Service Bulletin

Bulletin No.: PI0631

Subject: Engine Wiring Harness Rubbing on Transmission, Various DTCs Set, Malfunction Indicator Lamp On

Models: 2012 Chevrolet Impala
Vehicles without RPO NU6 Emissions
Built Prior to December 1, 2011

2743910

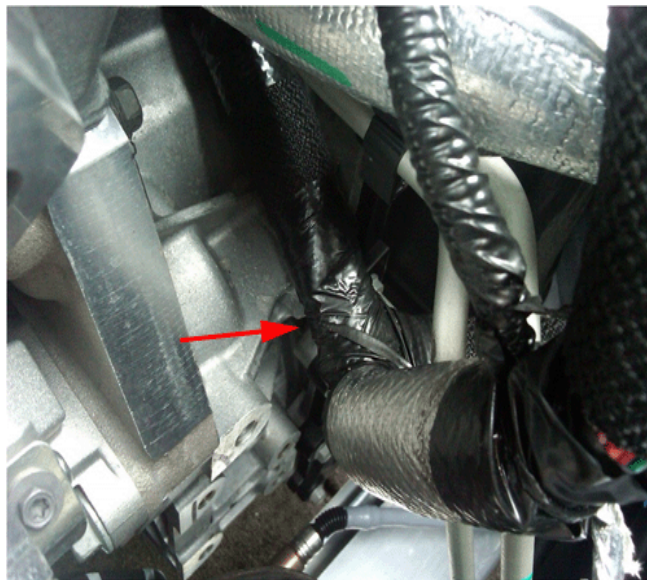
Some customers may comment on a malfunction indicator lamp on. Technicians may find DTCs P0641 and/or P06A3. Other DTCs may also be set.

This condition may be caused by the engine wiring harness rubbing on the front right side of the transmission. The engine harness may have chafing or damage to the wires. Contact with the edge of the transmission may result in a rub-through of the wires within that harness.

If necessary, peel the tape from the area and look for ANY damaged wires. Repair the harness as necessary. Refer to Wiring Repairs in SI.

Wrap harness conduit around the affected area of the harness and tie strap to the transmission cooler line bracket. If chafing is not observed, refer to the appropriate diagnostic procedures in SI.
